ADDENDUM 2 – *Demolition of Travel Agency, Garage, and Bank Building*

Date: June 26, 2014
To: All Potential Bidders
From: Village of Orland Park
RE: Questions and Answers

Demolition of Travel Agency, Bank and Garage Exhibit E

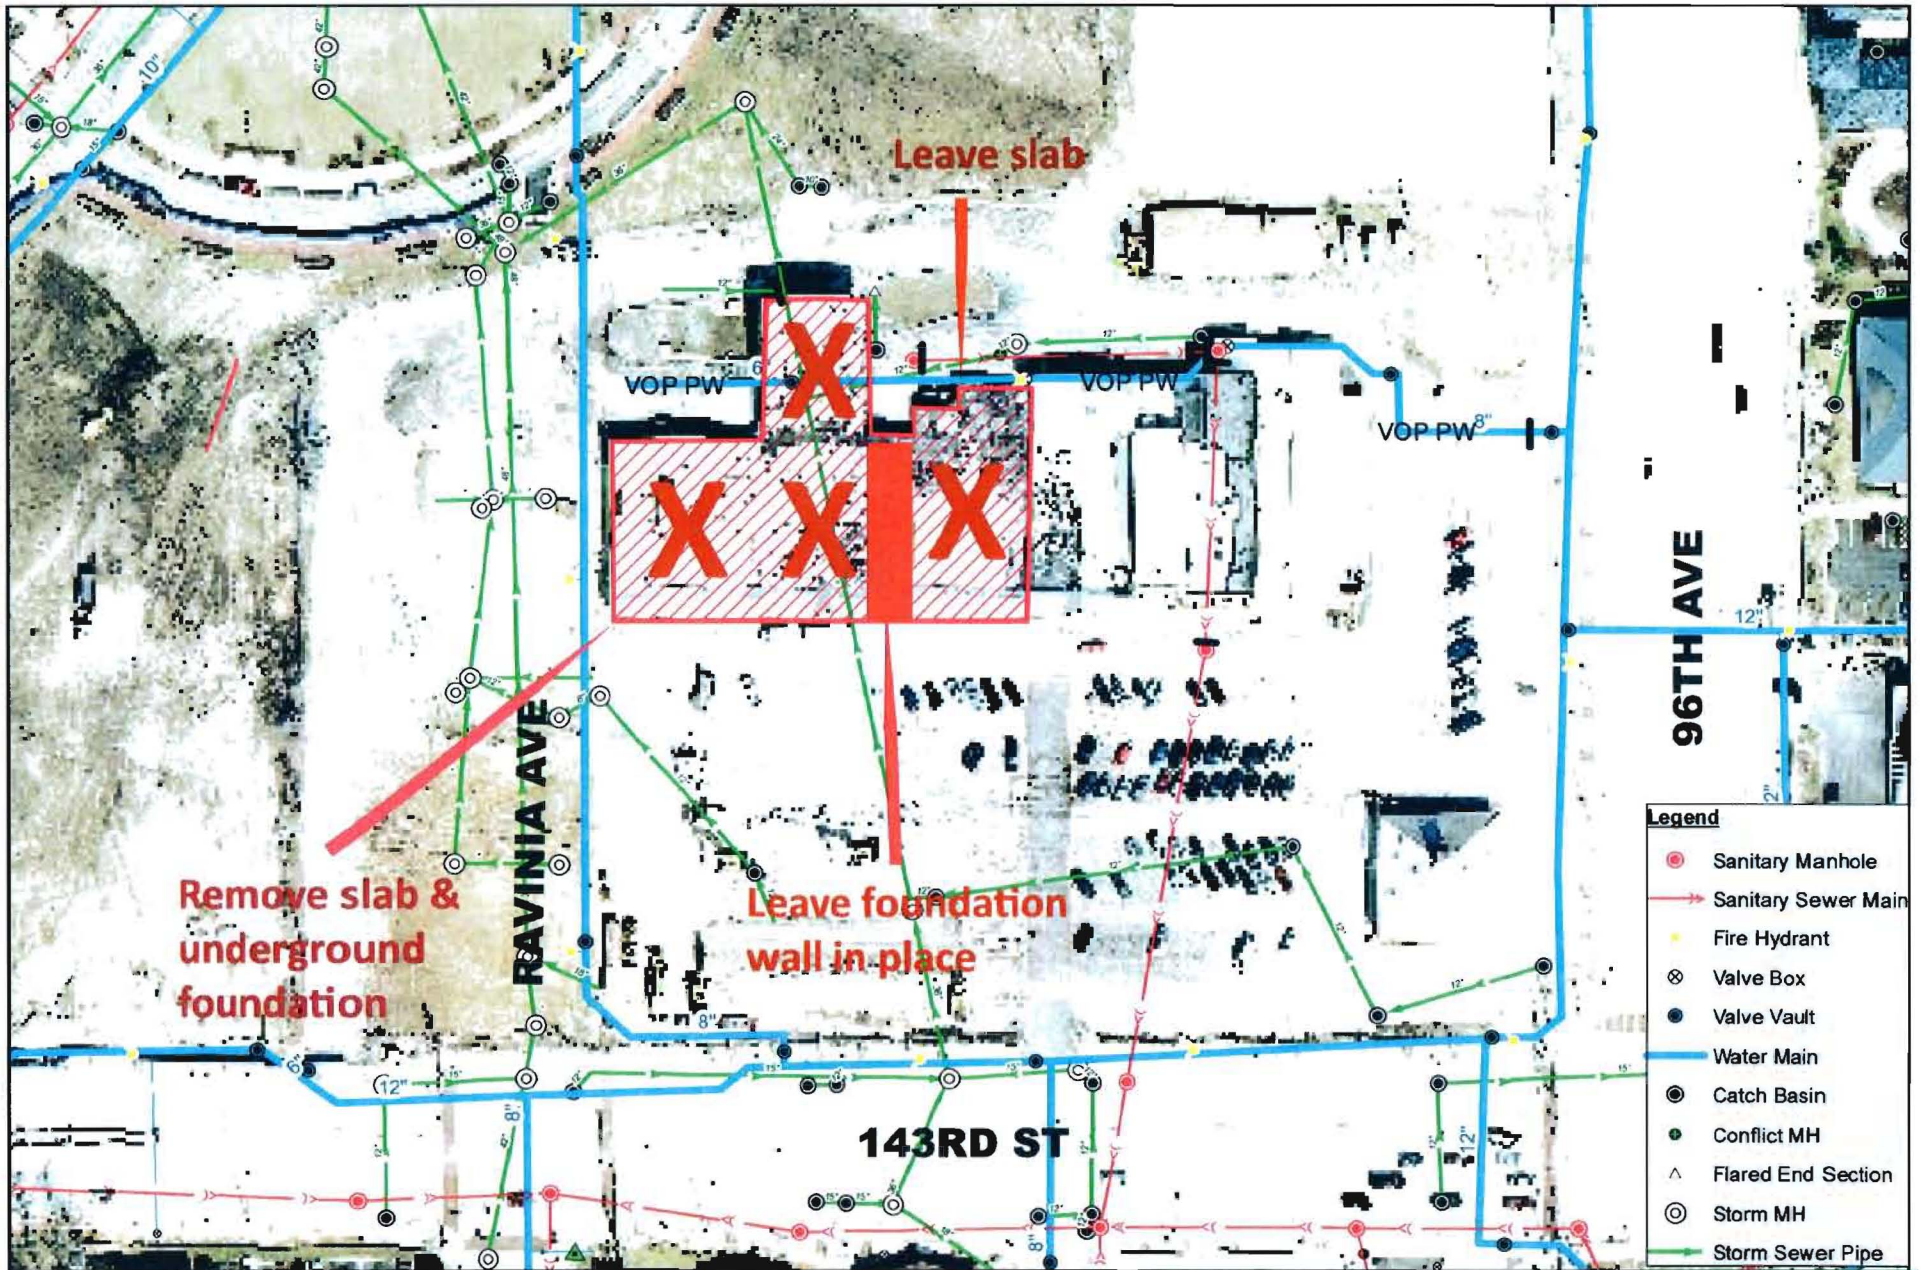
- Q1. There is nothing in the bid about removing concrete pad and foundation to the west of the buildings but at pre bid they said it was included? Please clarify.
- A1. *Yes it is included. Remove all upper and lower concrete, just leave the foundation wall as stated on the Exhibit E as marked.*
- Q2. Also are we supposed to crush to concrete as fill or bring in suitable fill?
- A2. *Use what is there with the hill of fill and crush all other concrete to no larger than 3" and compact as in bid specs.*
- Q3. Can the masonry and concrete be used as backfill for the project?
- A3. *Yes*
- Q4. If the masonry and concrete can be used as backfill what would be appropriate sizing?
- A4. *No larger than 3"*

- Q5. What is the diameter of the sewer line that will be filled with flowable fill?
- A5. *The sanitary sewer main is an 8" main.*
- Q6. Where or how far out does the sewer line have to be filled? On the outside of the foundation wall or inside the property line north of 143rd street in the parking lot?

- A11. *Yes there is and it is being removed by owner (outside contractor).*
- Q12. Can the Norman's property boundary be identified on Exhibit C so that the contractor is aware prior to bid submittal of those areas where no subsurface work is to occur (ref. Special Condition (1))?

- A6. *The sanitary sewer main is required to be filled between the manholes. The southern sanitary manhole is approximately 20 feet to the south of the building. The abandoned pipe is required to be plugged in the sanitary manholes per the specifications.*

- A12. *It is marked on Exhibit E - it shows the area.*
